Index 700-040 Cantilever Sign Structure

COMMENTS AND RESPONSES

SECTION A-A

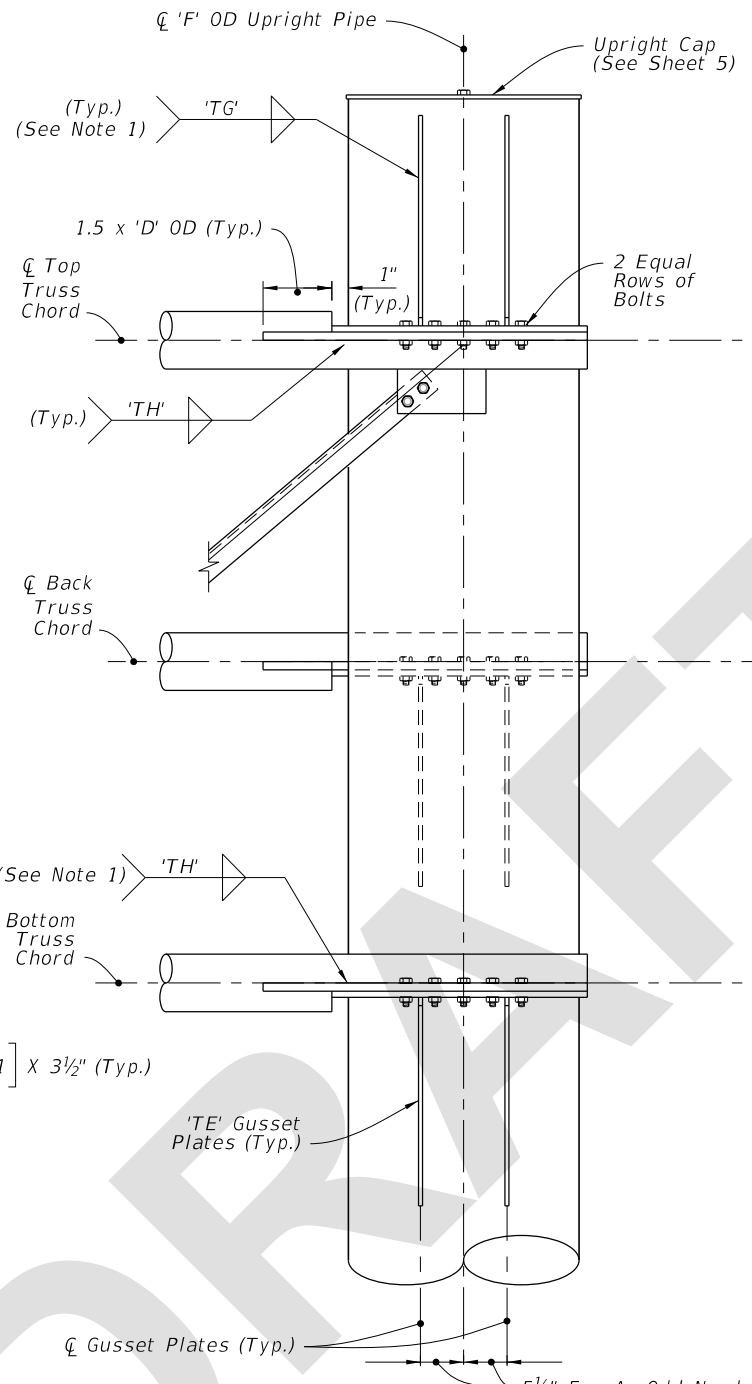
COMMENT: The line work in Section A-A on sheet 3 should be corrected as shown in the markup provided. The callout in Detail F on sheet 4 should match the callout in Detail E.

RESPONSE: Agree. Both changes will be made with the final revisions.

Change made to Index: Update Sheet 3 and Sheet 4 based on comments.

UPRIGHT-TRUSS CONNECTION DETAIL

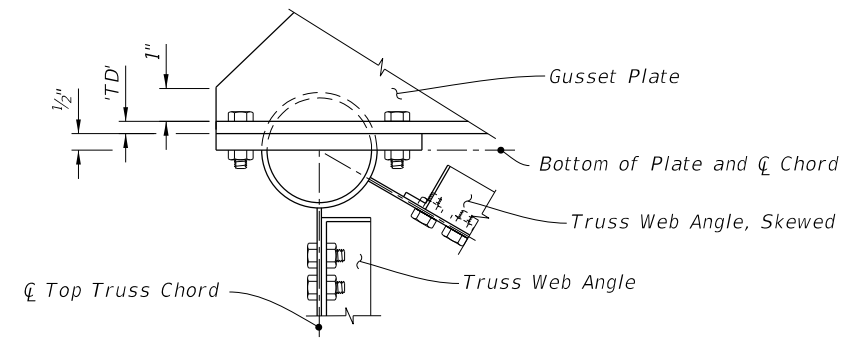
COMMENT: It's not clear wear welds from plates to tubes should be wrapped.

RESPONSE: Standard has been updated to more clearly specify where the welds should be wrapped.

Change Made to Index: Annotations added to UPRIGHT-TRUSS CONNECTION DETAIL on sheet 3

DETAIL 'F'

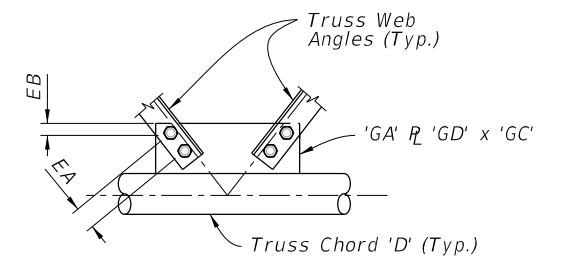
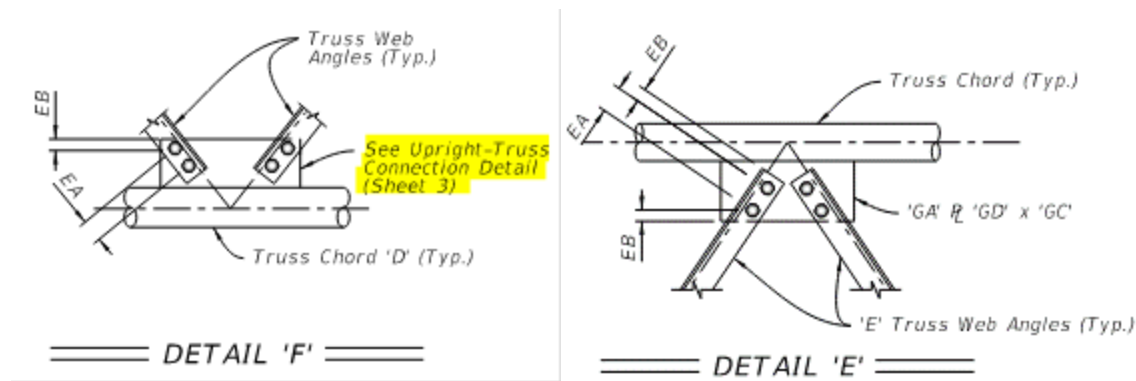
COMMENT: Since you're in the process of looking at these Standards, something came up recently on a project regarding DETAIL F on sheet 4 of 5 of Index 700-040.

In SECTION B-B, DETAIL 'F' is shown in the middle of the cantilever:

However, despite not being anywhere near the Upright, DETAIL 'F' directs us to "See Upright-Truss Connection Detail (Sheet 3)" in reference to the gusset plate. Additionally, there is no indication of what size that gusset plate is. We presume that that plate is the same as the gusset plate in DETAIL 'E' given the geometry of the truss, but they are drawn slightly different.

To me, there is nothing obvious about the UPRIGHT-TRUSS CONNECTION DETAIL that DETAIL 'F' would be directing us to.

RESPONSE: Thanks for the comment. We agree that the callout on Detail F should be revised to match Detail E.

Change made to Index: Callout in Detail F updated to match Detail E.
